APPEAL SUMMARY

| Appeal ID: 20748 | Project Address: 525 SE MLK Jr Blvd |

Appeal item 1

| Code Section | OSSC 2014 – Section 602.3 |

ROOF PLAN

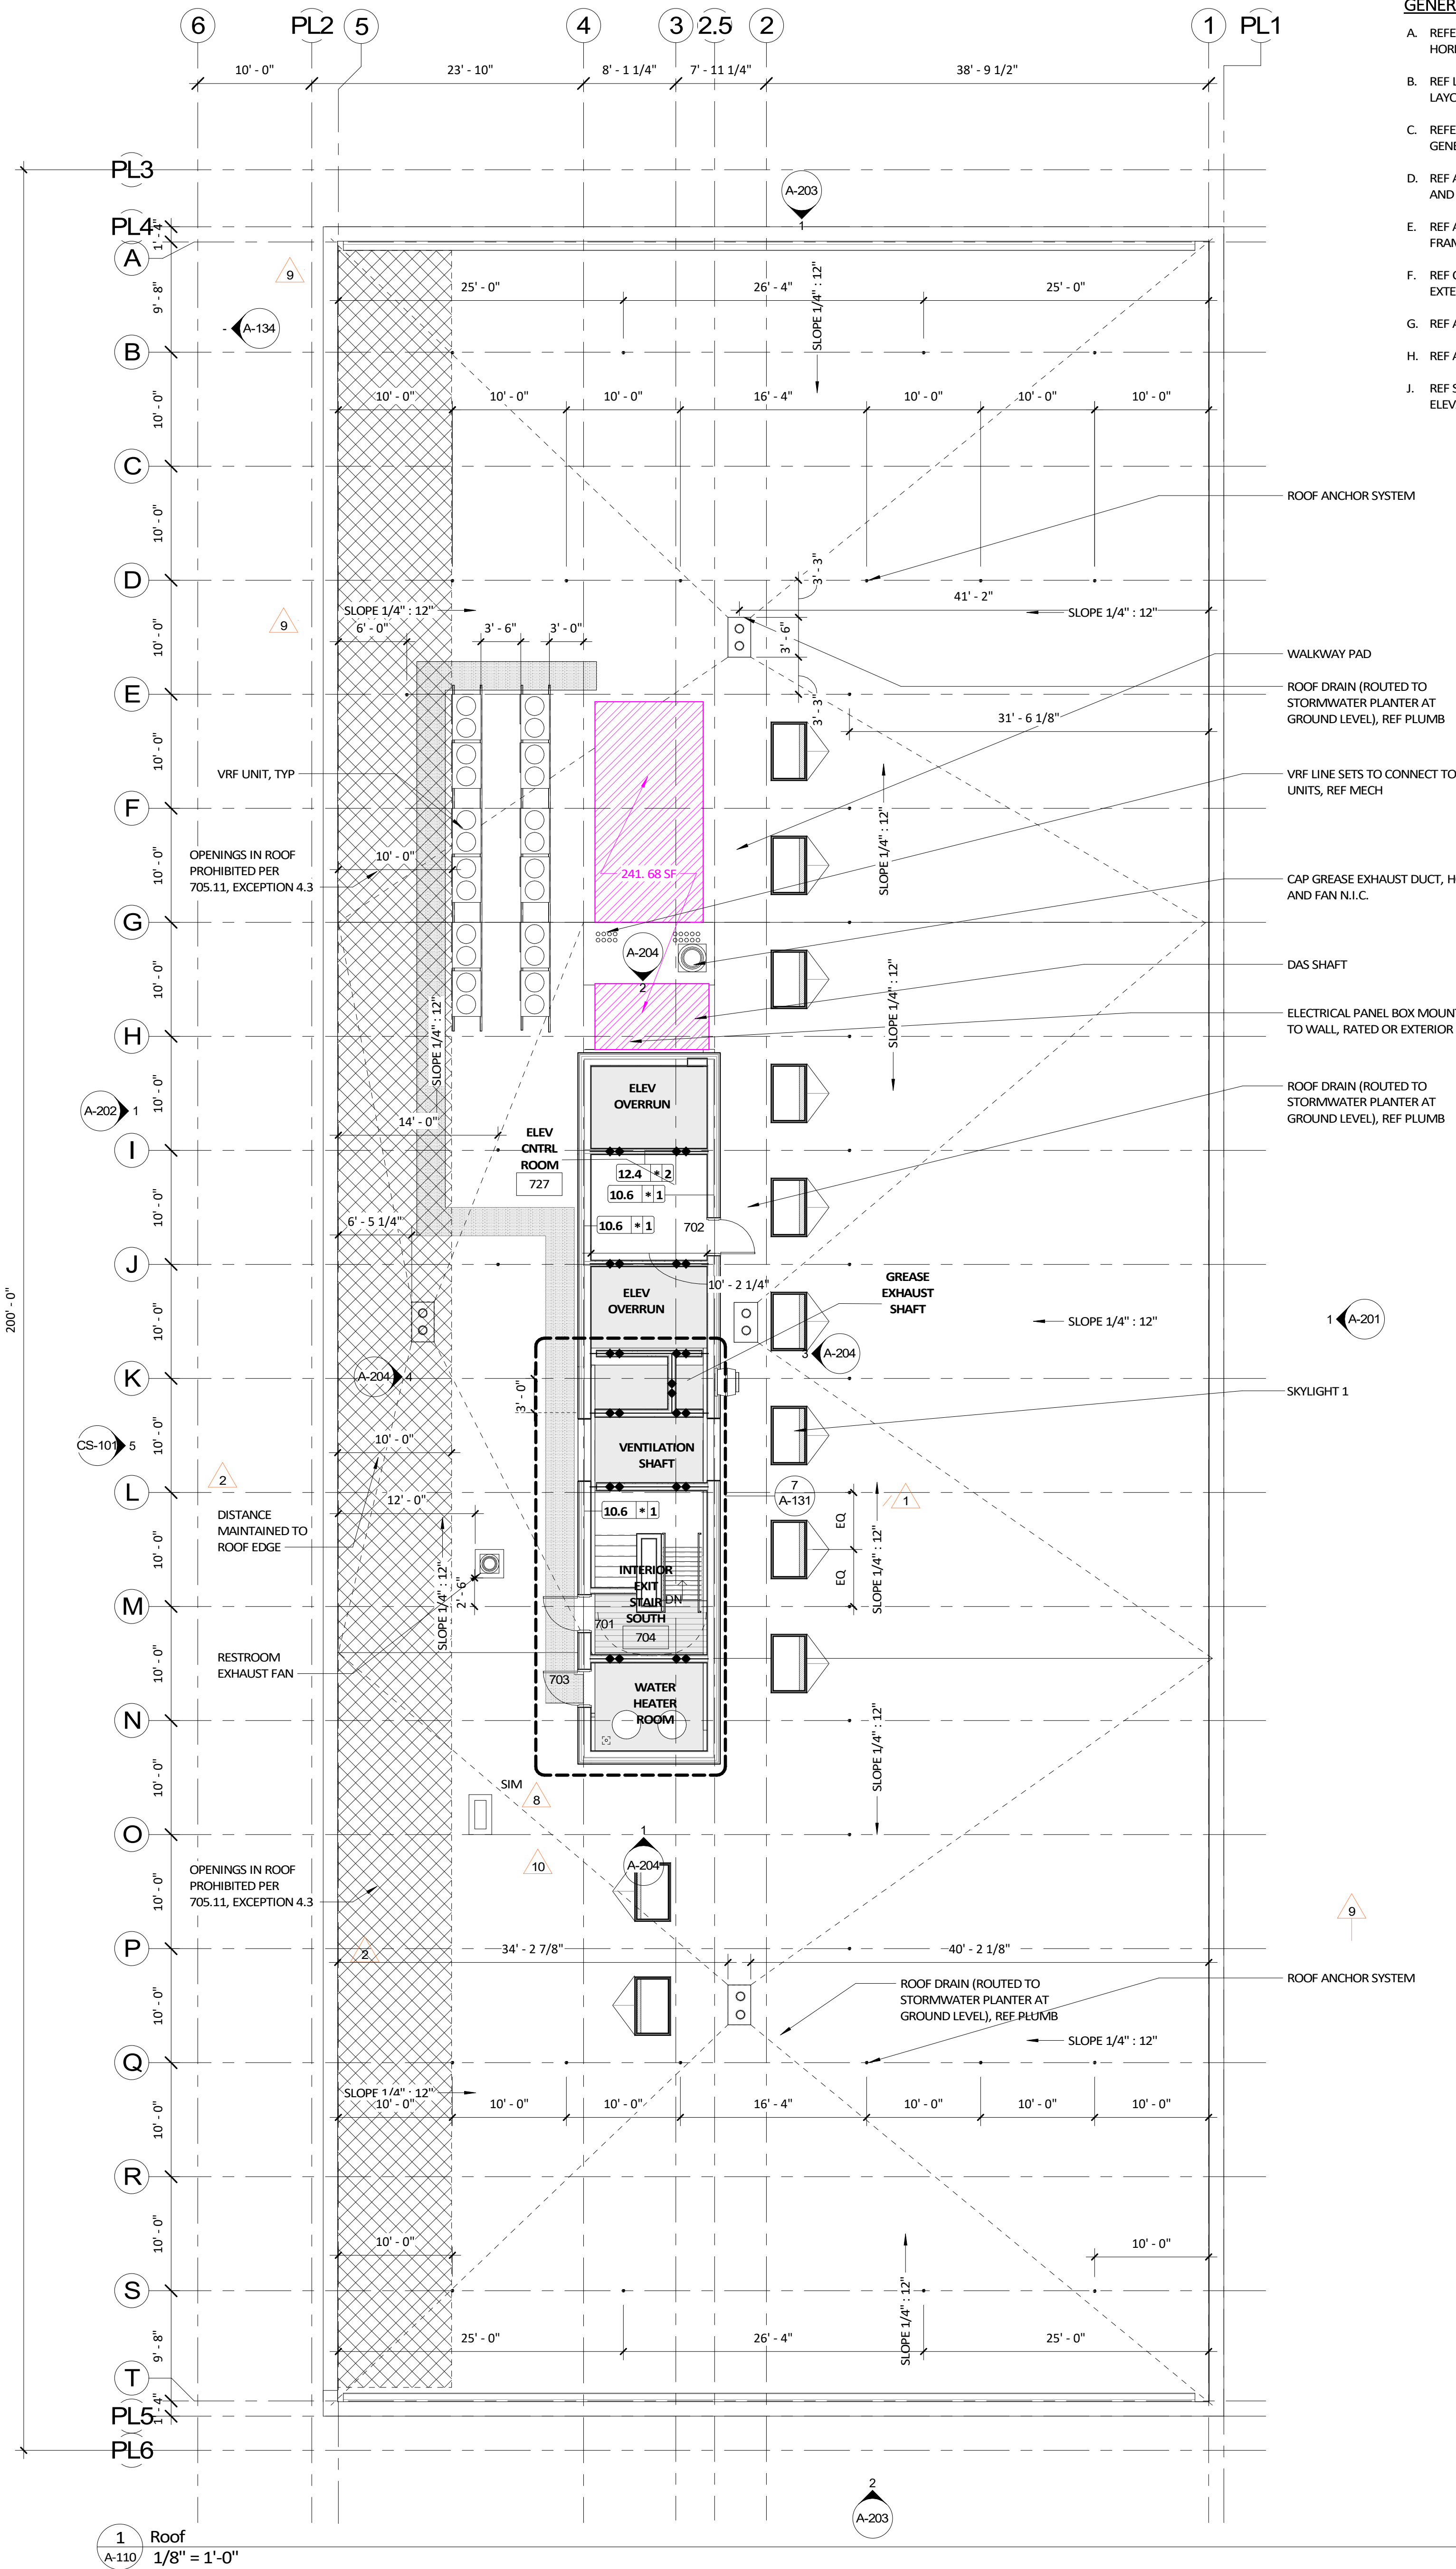
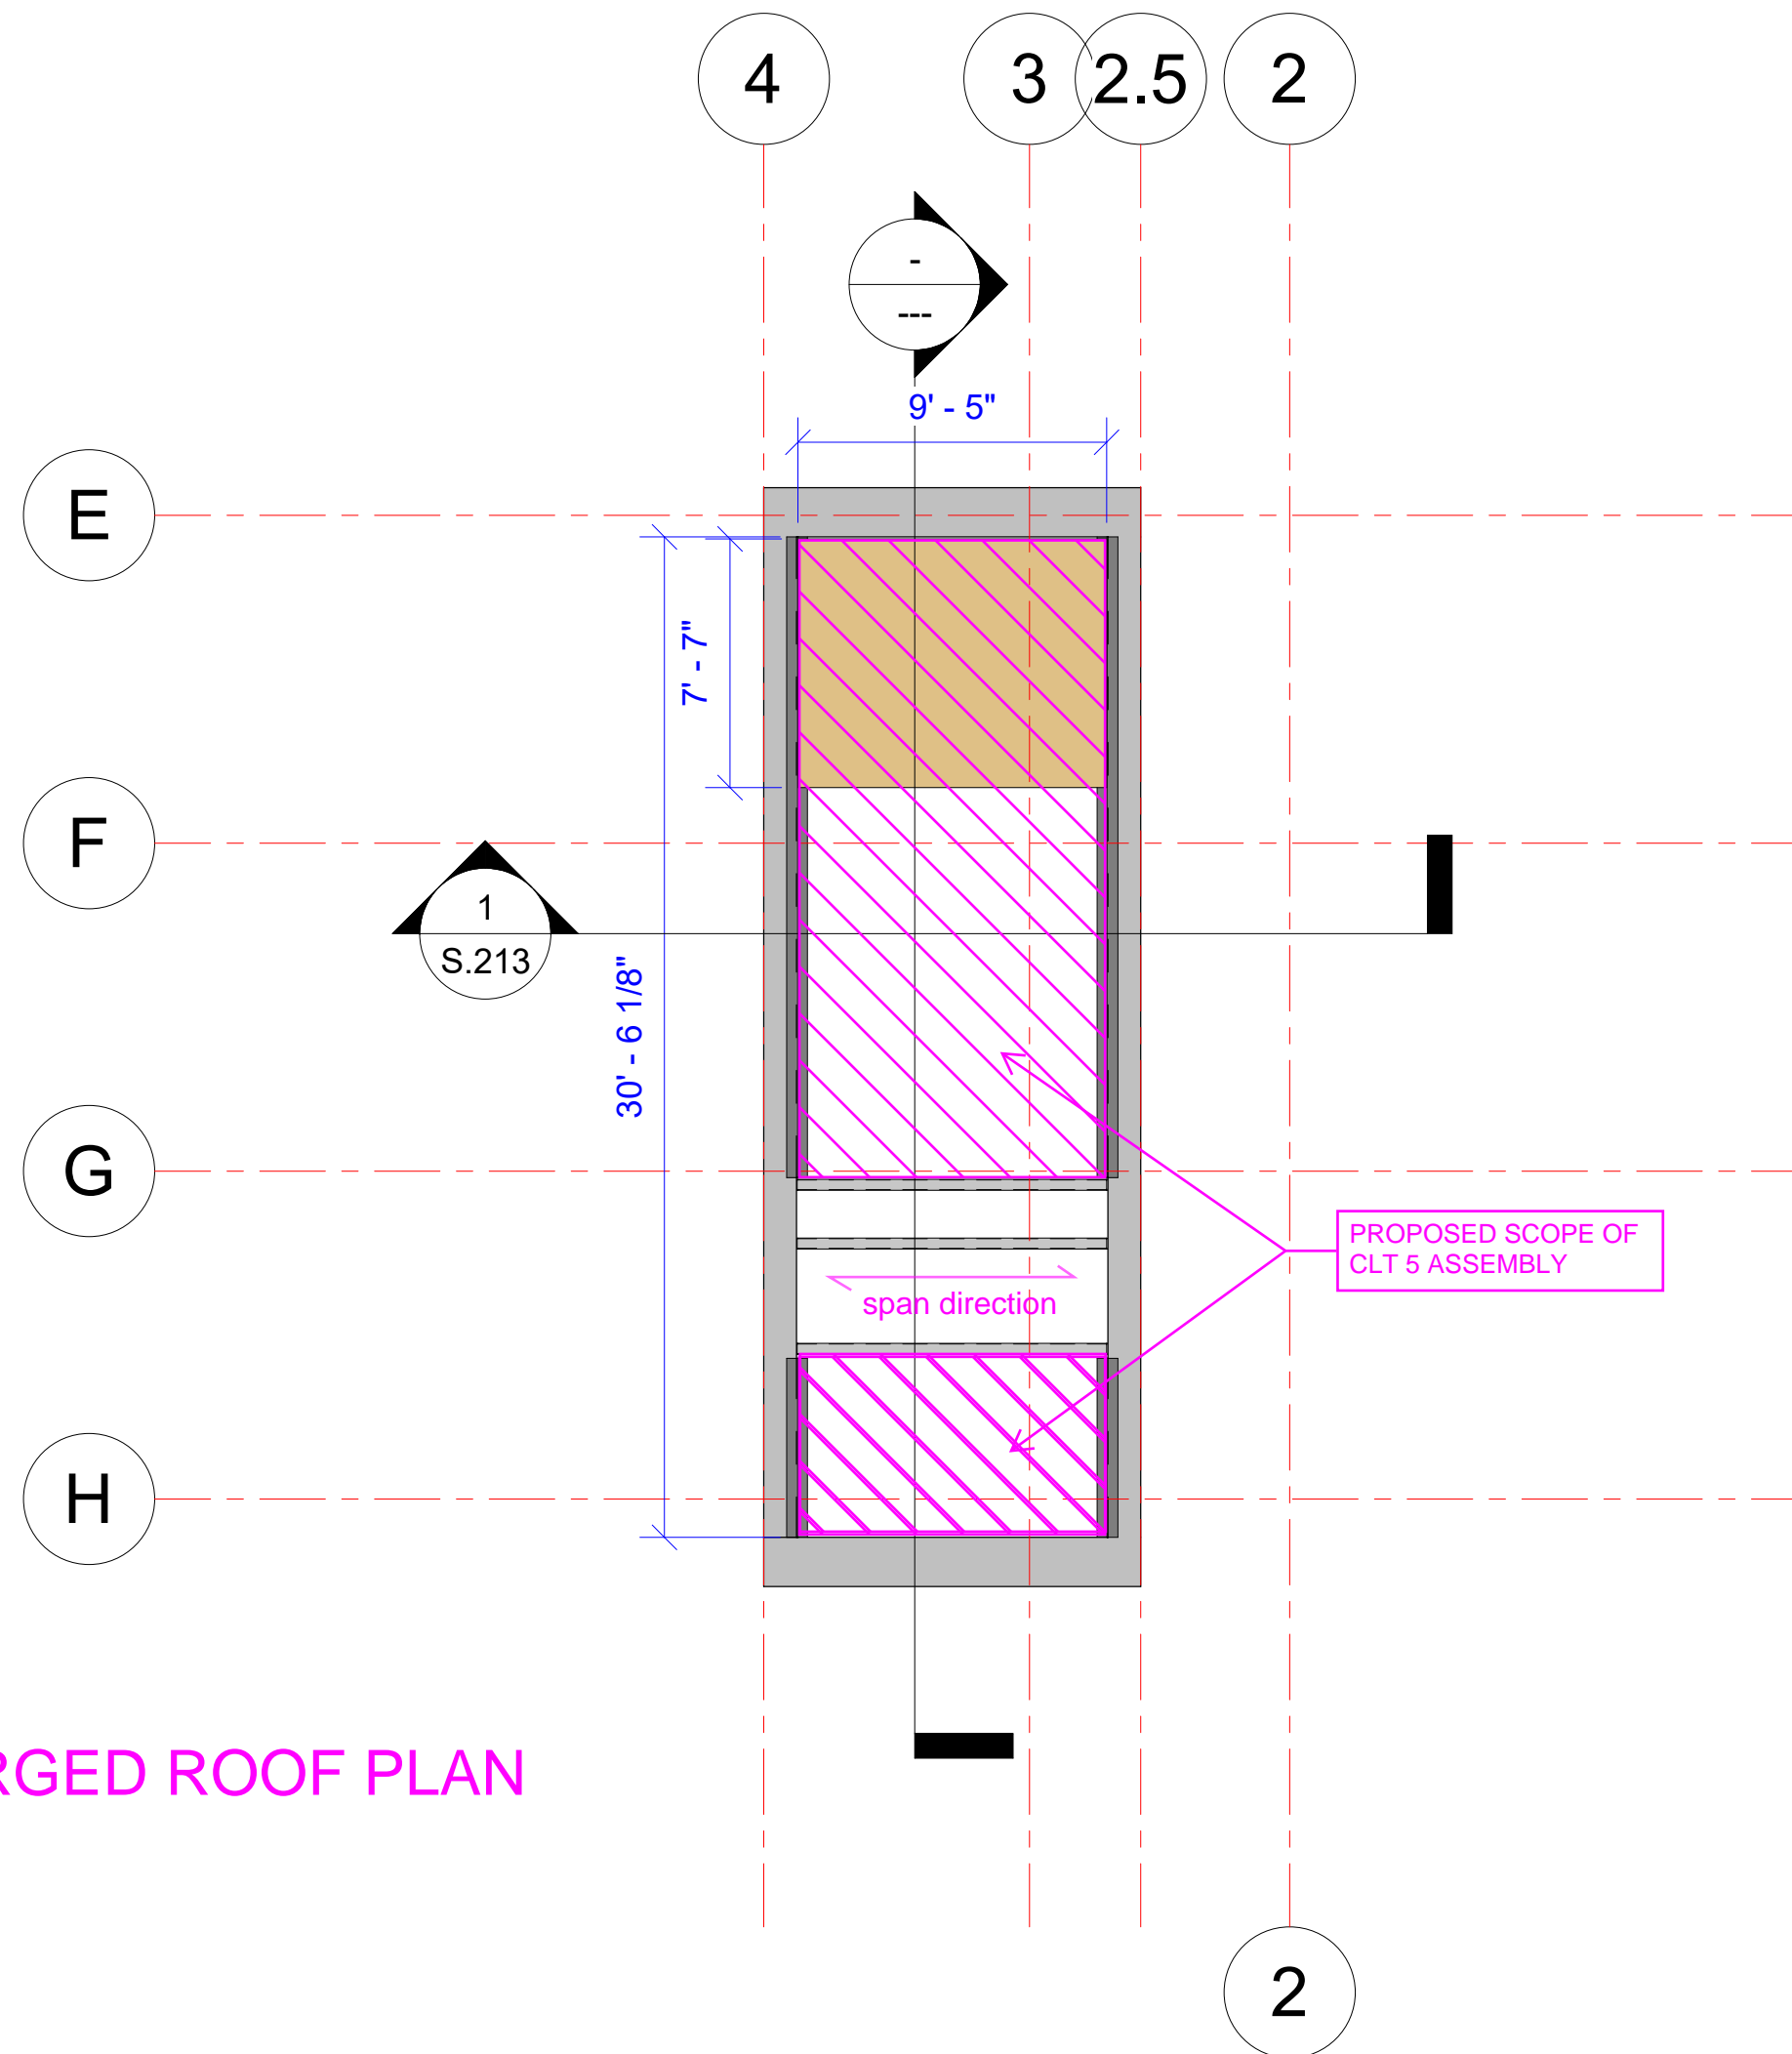
| Proposed Design | <p>CONTEXT: This project is a 6-story office building with a composite roof structure consisting of 3-layer cross-laminated timber (CLT) panels topped with a 3" reinforced concrete slab supported by glulam beams and columns and a pair of concrete cores. Construction is underway with anticipated TCO near the end of the year.</p> <p>PROPOSED CONDITION: For constructability purposes, instead of the typical composite roof assembly, we are proposing that a small portion (~242 sf) of the roof structure, located solely on top of one of the concrete cores, be a 5-Layer CLT panel. The proposed edge support for the CLT 5 panels are steel ledgers hung from the 2-hour rated concrete stair core walls. Any exposed conditions of the Steel ledgers are to be fire proofed per code defined means.</p> |
| Reason for alternative | <p>The entirety of the roof surface has already been erected and the topping slab has been poured with the exception of the portion of the roof being proposed to be CLT 5. This area has been left open to allow for stair elements to be lowered into the concrete core via crane. It is the preference of the construction team to switch the assembly at this location so that a topping slab and the associated 30-day curing time can be avoided so that roofing membranes and subsequent roofing layers can be installed immediately after the CLT 5 panels have been installed.</p> <p>The 2012 National Design Specifications for Wood Construction does not address a char rating design procedure for exposed CLT panels. We propose that the CLT floor installation matches the</p> |

Note this assembly includes CLT 5, splices/splines are half-lap spines with 6” SDWS screws @ 8” o.c., and ½” plywood topping with 8d nails. Span = 13.5’ Load=113 psf for a 2-hour assembly (although in the proposed application only a 1-hour rating is required.)

Type IIIA construction with alternate 1 hour roof assembly: Granted as proposed.
